CITY OF CONWAY, ARKANSAS HISTORIC DISTRICT COMMISSION

HISTORIC DISTRICT COMMISSION

May 23, 2022

FRONT ELEVATION

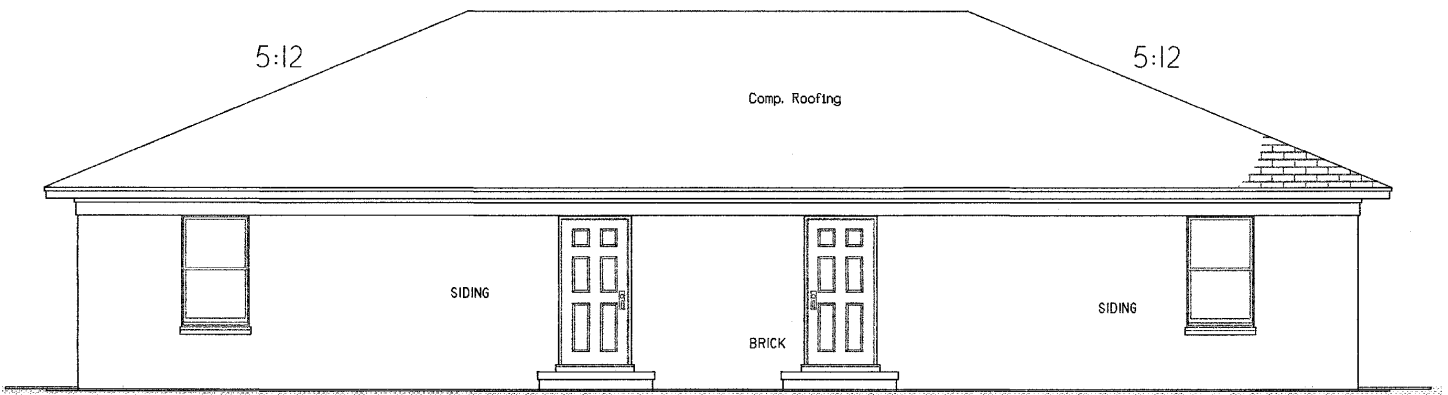
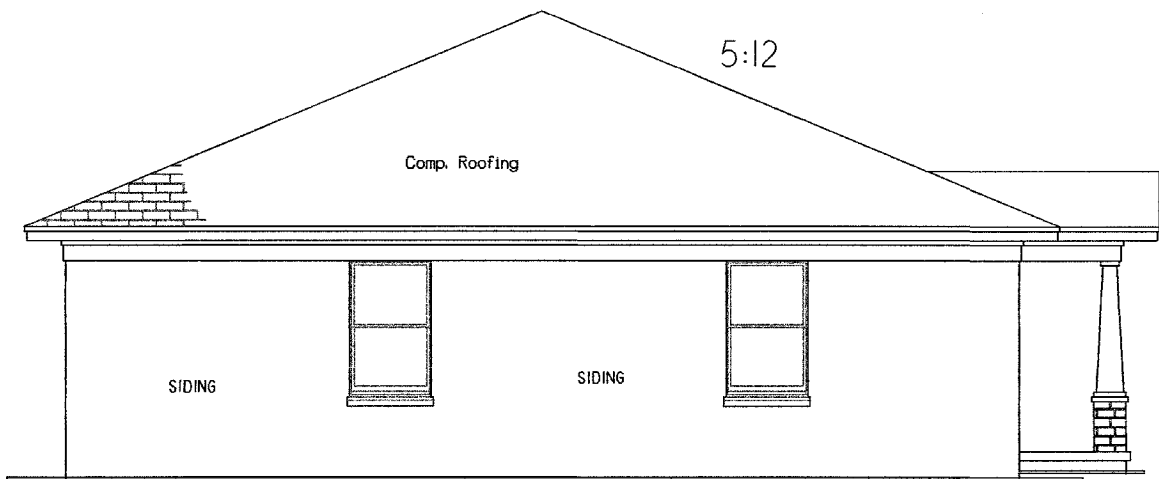
An open front porch with a 4' depth is proposed. Regulations require at least a 6' depth porch. The proposed vinyl windows are appropriate, but should feature wide trim and be placed further below the eave.

The applicant is proposing board and batten siding. Recommend limiting the used of board and batten to the upper gables given its limited use in the immediate area.

The slab construction of the foundation does not appear to have a compatible appearance. Recommend requiring a crawlspace or a taller slab to have a more compatible appearance.

The applicant is proposing a roof with a 5/12 pitch. This roof form gives a more contemporary suburban appearance consistent with the immediate area. Recommend requiring an additional front facing gable with a rectangular or circular attic vent for each unit.

3. Planting of 5 additional canopy trees is required. If the cedar tree is removed it shall be replaced with a new canopy tree.
4. Require all windows be 1-over-1 design, feature wide trim, be placed approximately a foot below the eave line.

5. Require wood, Hardie® siding/LP SmartSide® to be used on the structure with board and batten limited to the gables.
6. Require crawlspace construction or taller slab to mimic the appearance of a crawlspace as found throughout the district.

7. Require an additional front facing gable with a rectangular or circle attic vent for each unit.
8. Require fascia and soffits to be finished with wood or wood equivalent construction (Hardie® siding).

Lot-269C Replat
#2022 WEEMS STREET

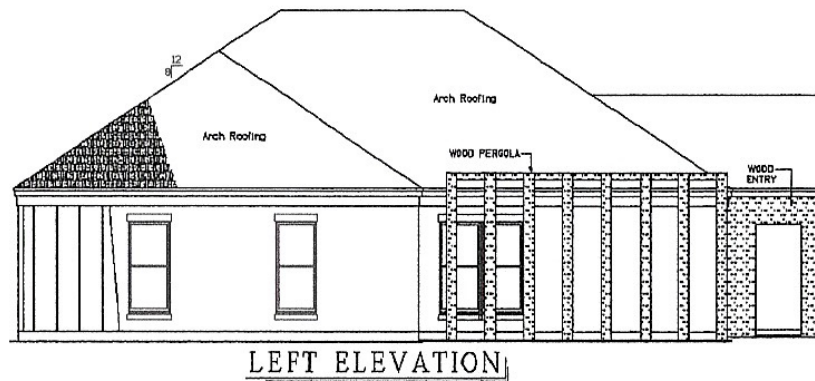
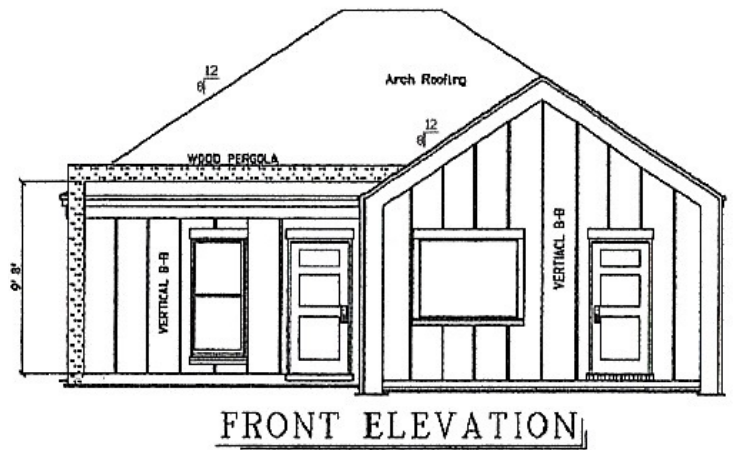
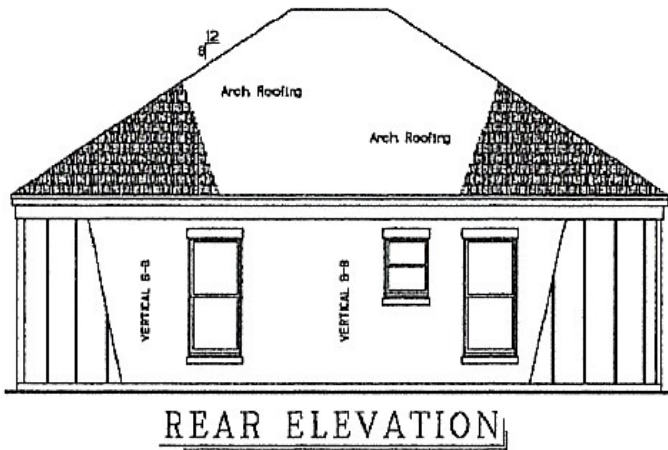
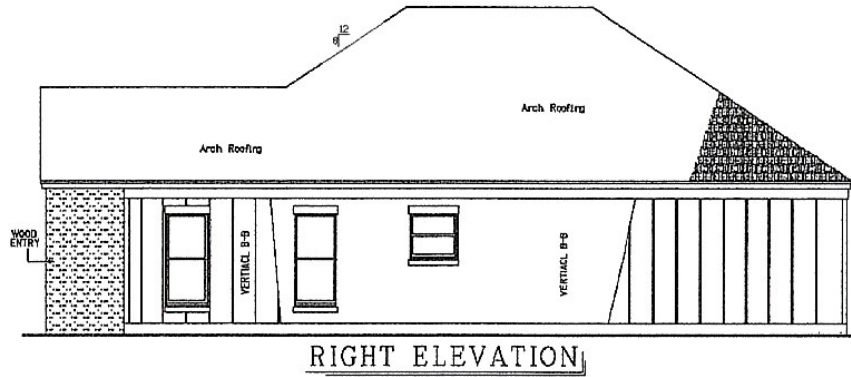
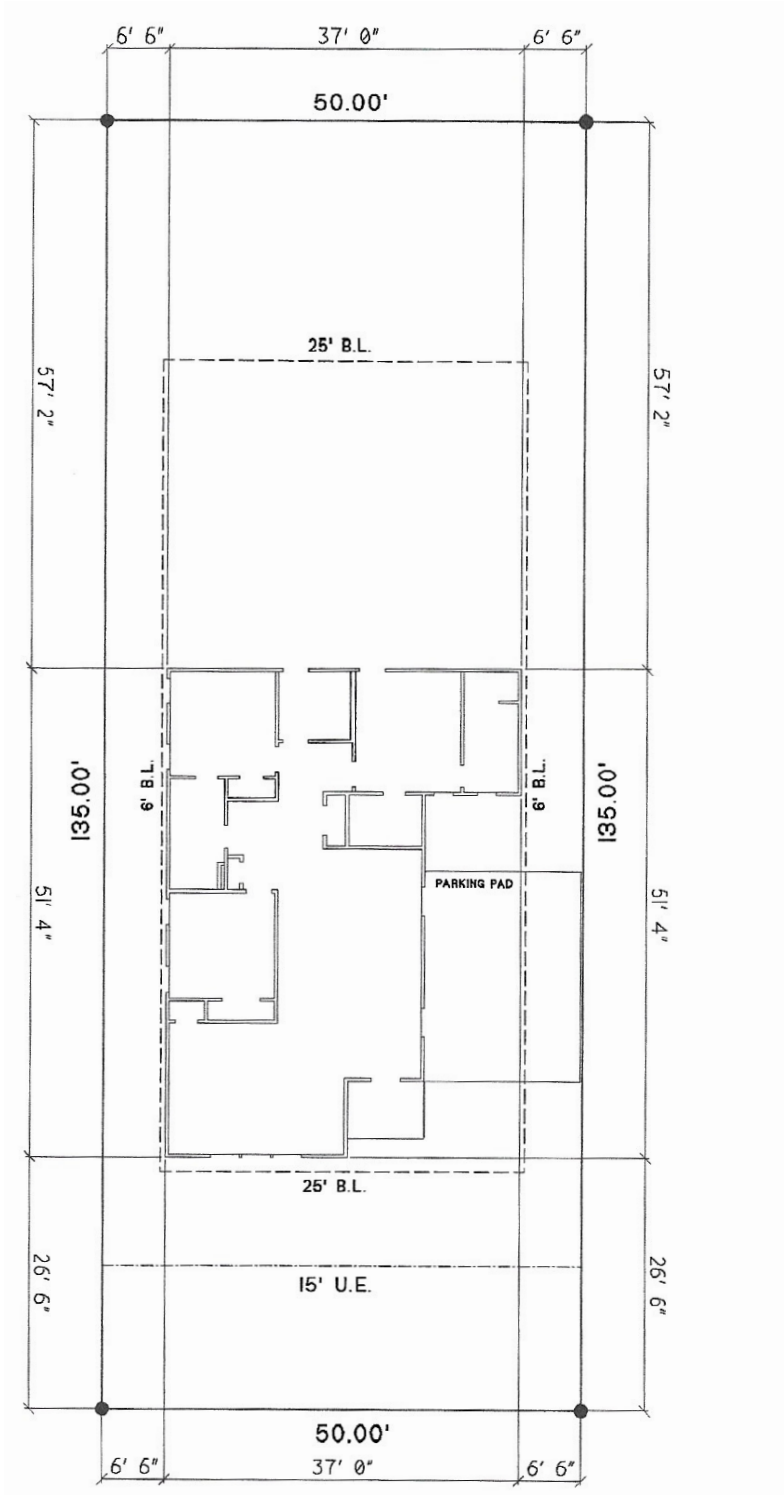
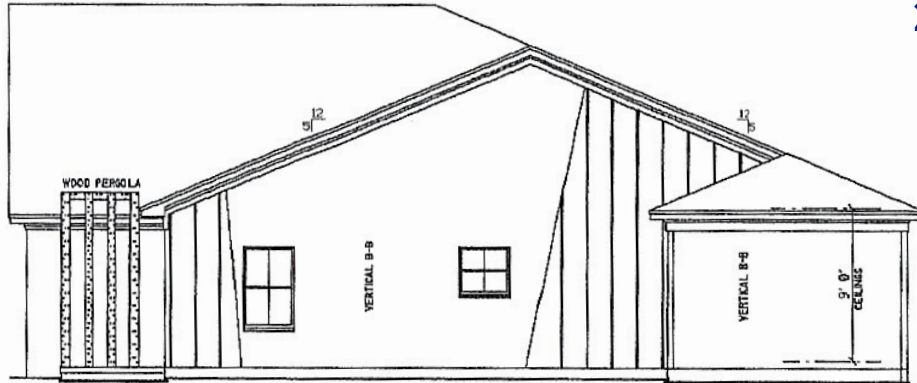
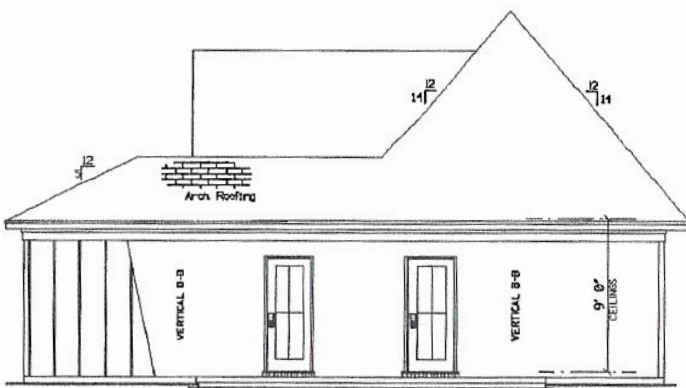
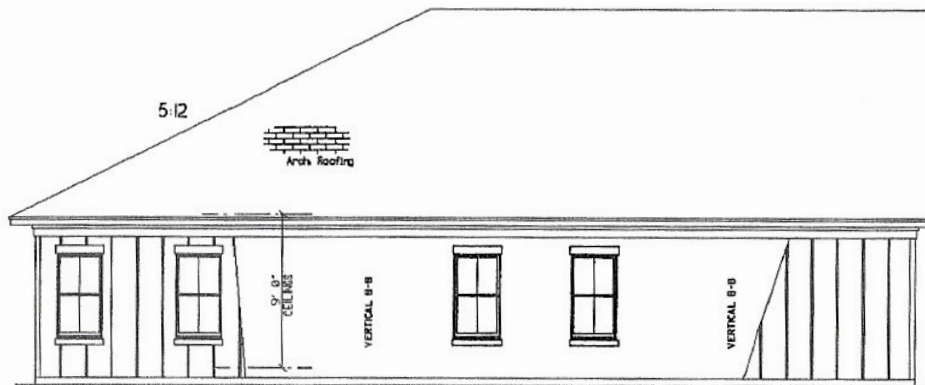
The applicant has not indicated driveways on the plans. The applicant has indicated 15' wide parking pads for both lots. 2024 Weems (west) features a parking pad placed directly on the property line. 2022 Weems (east) features a partially covered parking pad under a wooden pergola. The plans cannot be adequately evaluated due to a lack of information on the plans for driveways.

There are no existing sidewalks on the site. The applicant is not proposing sidewalks. A 5' sidewalk with a 6.5' greenspace setback is required along each frontage. No walkways are indicated on the plans.

Style. New design should respect the context of the area while expressing the contemporary nature of the structure. The surrounding area does not have a cohesive theme of styles, mixing traditional, historic vernacular, and contemporary elements. *The design of 2024 Weems (west) appears to be generally compatible in design with the surrounding area using traditional forms and patterns. The design of 2022 Weems (east) does not appear compatible with the surrounding area with a design that appears generally more modern (non-traditional porch form) and roof form mimicking suburban form houses.*

Entries, Porches, and Porticos, Doors and windows, Awnings. Porches are encouraged and should be at least 6' deep, when present. Entries should contain special decorative elements and ornamentation. Windows should be of divided-light construction, where divided-light windows are proposed. Fake muntins are not permitted. *An open front porch with a 6' depth is proposed for 2024 Weems (west) with 5' for 2022 Weems (east). Regulations require at least a 6' depth porch. The use of a pergola for a porch on 2024 Weems (west) is not compatible with the general area, given the use of a recessed entry. Applicant is recommended to consider using an English Revival style "swoop" transition between the main gable and porch. The porch form for 2022 Weems (east) is not compatible with the general area. The proposed vinyl windows are appropriate, but should feature wide trim and 1-over-1.*

Architectural Details, Siding, and Bricks. Detailing and siding should complement the surrounding area. Siding should include brick, stone, wood, or Hardie® siding/LP SmartSide® type siding. *The applicant is proposing board and batten siding for both structures. Recommend limiting the use of board and batten to one structure and require lap siding for one of the structures. The slab construction of the foundation does not appear to have a compatible appearance. Recommend requiring a crawlspace or a taller slab to have a more compatible appearance.*

Shutters, Roof, Decks/Plaza Space, Skylights, Mechanical Screening. Roofing should respect the character of the surrounding area with respect to materials, pitch, and form. Metal roofing is prohibited unless historically used on the structure. *The applicant is proposing a variety of roof forms for the houses. This roof forms for 2024 Weems (west) appear compatible. The hip roof form for 2022 Weems (east) gives the structure a more suburban appearance that is not compatible to the district.*

Staff recommends tabling the application to allow the applicant to submit additional information on driveways, sidewalks, and walkways as well as correct architectural elevations to provide designs compatible with the regulations and general area.

#1837 SIMMS STREET
LOT 1 BLOCK 59
BOULEVARD ADDITION

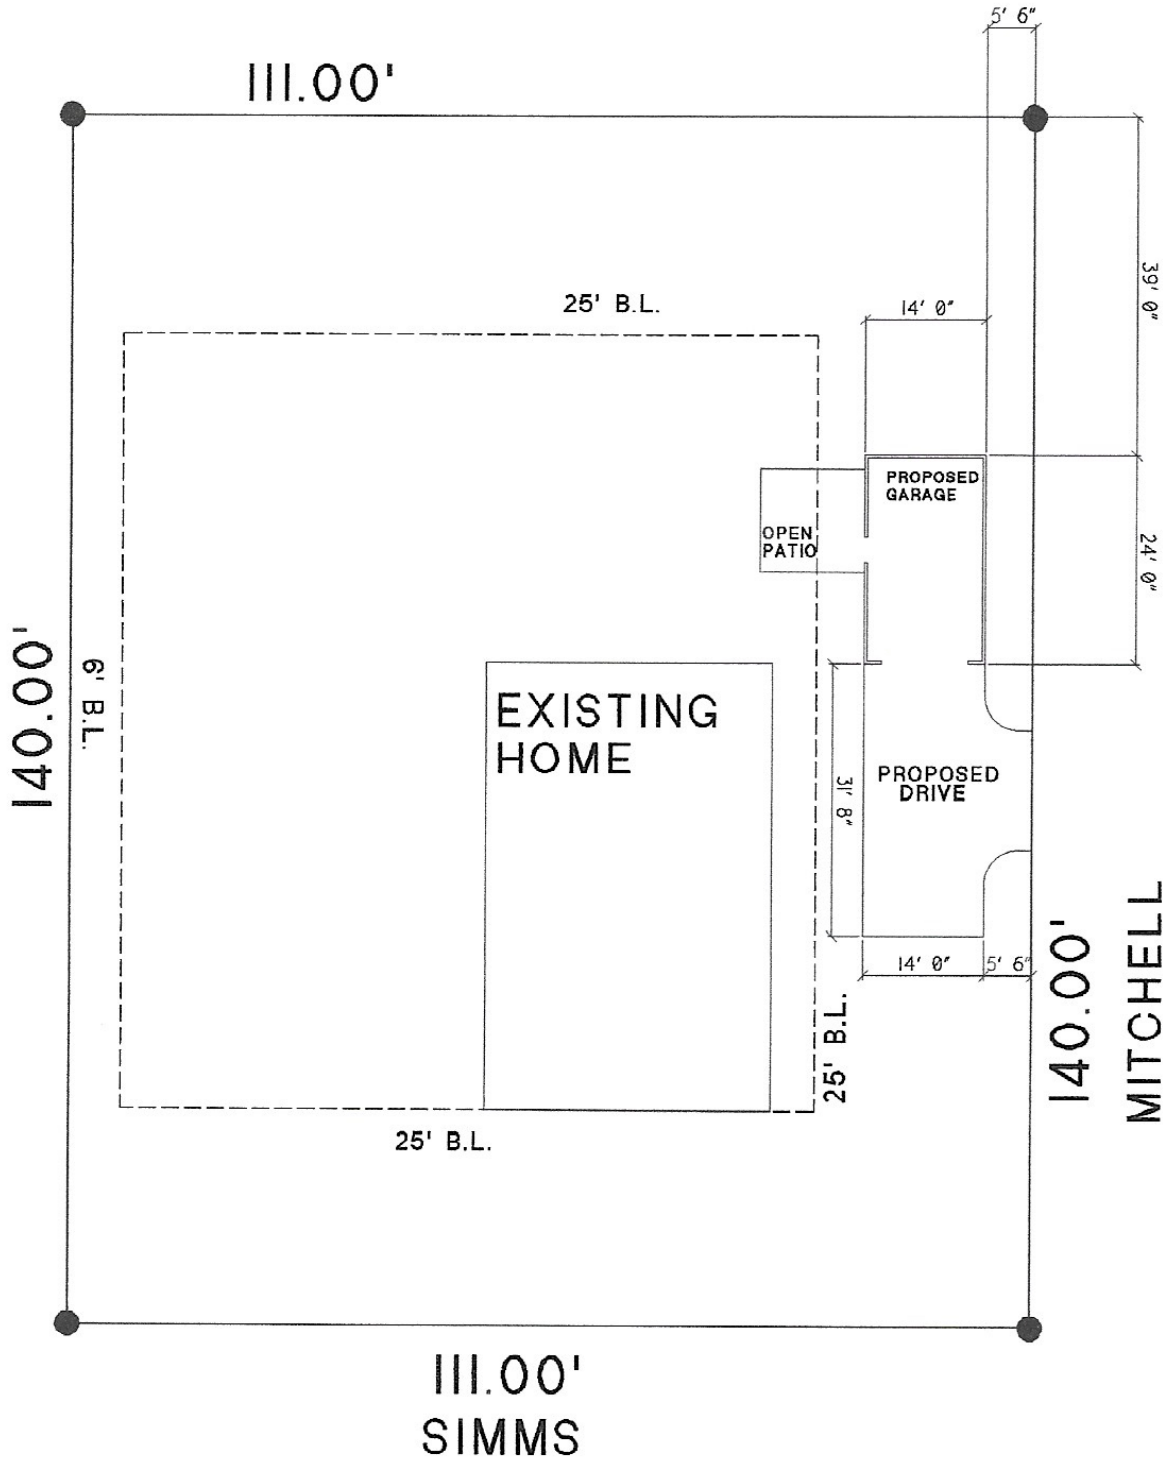
The structure is proposed to be placed behind the primary structure with a proposed side setback of 5'-6". Recommend requiring the setback be placed in line with the building line of the side façade of the house.

The proposed carport is not placed in a manner consistent with the requirements of the ordinance. Recommend requiring the garage face Mitchell St and be placed in line with the building line for the side of the structure.

1. Require the garage be reoriented to face Mitchell St and setback in line with the building line for the side façade of the house.
2. Require fascia and soffits to be finished with wood or wood equivalent construction (Hardie® siding).
3. HVAC equipment be placed in a manner to minimize its visibility from the street.
4. The property shall be replatted prior to obtaining building permits.
5. Submit revised drawings to the Planning Director for approval prior to release of the COA.
